UNITED STATES
NUCLEAR REGULATORY COMMISSION
OFFICE OF NUCLEAR REACTOR REGULATION
WASHINGTON, DC 20555-0001

NRC INFORMATION NOTICE 2017-05, Revision 1: POTENTIAL BINDING OF SCHNEIDER
ELECTRIC/SQUARE-D MASTERPACT
NT AND NW 480-VAC CIRCUIT
BREAKER ANTI-PUMP FEATURE

Figure 1: The XF coil in the original logic is replaced by an XFCOM coil, which releases the close coil plunger as soon as the close signal is received, eliminating the potential for binding.

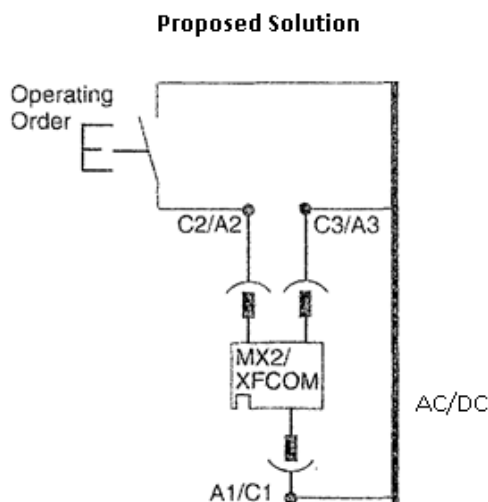
In Technical Bulletin TB-12-007, Revision 3, which is attached to the referenced 10 CFR Part 21 report (ADAMS Accession No. ML16278A471), AZZ/NLI provided a proposed modification to the breaker and an updated circuit diagram, shown in Figure 1 of this document. This modification replaces the normal XF (closing) coil in the breaker with an XFCOM coil. The XFCOM coil acts as a oneshot and releases the close coil plunger immediately after the close signal is applied to the breaker and will not reactivate the close coil plunger unless power is first removed from the operating order signal of the XFCOM and then re-applied. With the closing coil plunger retracted, this modification is designed to eliminate the potential for mechanical binding from the anti-pump feature.
